Access Compliance Report

Public Rights-of-Way

Intersection ID: N/A	Main Street: STEEL_CREEK_RD	Cross Street: ENTRANCE_DR	Location: SE
ADA ID: FD335CBE08AC	Ramp Type: PerpDiag	Initial Pass/Fail: Fail	Overall Compliance: No
Severity Score: 33.75			
Codes/Mitigation Info/Possible Solution		Field Measurements/Component Compliance

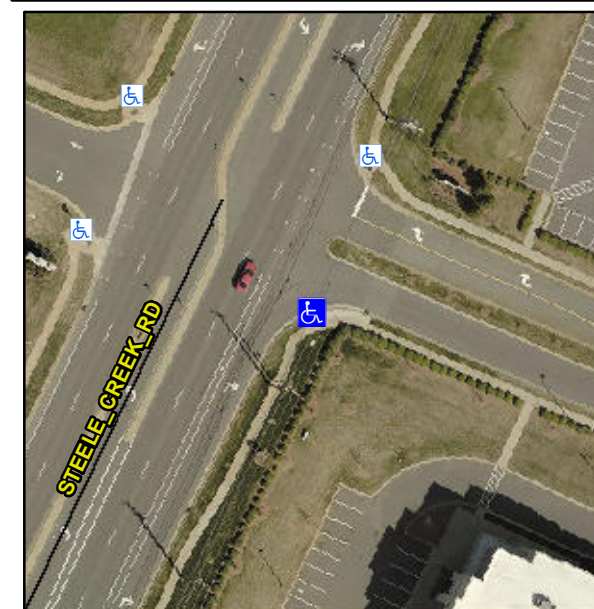
R304.5.1, R304.5.3

Compliance	Description	Data	Compliance	Description	Data
N/A	Ramp Length (in)	97.0	Yes	Ramp Slope (%)	6.9
No	Ramp Width (in)	47.0	No	Ramp XSlope (%)	7.8
N/A	Flare Type LT	N/A	N/A	Flare Type RT	N/A
N/A	Flare Slope LT (%)	N/A	N/A	Flare Slope RT (%)	N/A
N/A	Flare Traversable LT?	N/A	N/A	Flare Traversable RT?	N/A
N/A	Landing Length (in)	N/A	N/A	DWS Provided?	N/A
N/A	Landing Width (in)	N/A	N/A	DWS Contrast?	N/A
N/A	Landing Slope (%)	N/A	N/A	DWS Length (in)	N/A
N/A	Landing X Slope (%)	N/A	N/A	DWS Full Width?	N/A
N/A	Landing Curb? (Y/N)	N/A	N/A	DWS Offset (in)	N/A
N/A	Shared Landing?	N/A			
N/A	Gutter Ponding?	N/A	N/A	Gutter Slope (%)	N/A
N/A	Gutter Lip Ht (in)	N/A	N/A	Gutter X Slope (%)	N/A
N/A	Painted X Walk1?	No	N/A	Painted X Walk2?	No
	X Walk 1 Direction	To NE		X Walk 2 Direction	To NW
N/A	X Walk 1 Width (in)	N/A	N/A	X Walk 2 Width (in)	N/A
	X Walk 1 Slope (%)	1.7		X Walk 2 Slope (%)	4.2
	X Walk 1 X Slope (%)	6.0		X Walk 2 X Slope (%)	2.3

N/A	Ramp inside XWalk1?	N/A	N/A	Ramp inside XWalk2?	N/A
	Road Slope (%)	5.7	N/A	Clear Space?	N/A
	Road X Slope (%)	1.9	N/A	Clear Space to XWalk (in)	N/A
N/A	Any Obstructions?	N/A	N/A	Storm Grate/Utility Hazard?	N/A
	Obstruction Type			Storm Grate/Utility Type	
		N/A			N/A
			Yes	Surface Condition? (G/P)	Good

Remove & Replace Curb Ramp With Two New Directional Ramps or Equivalent.
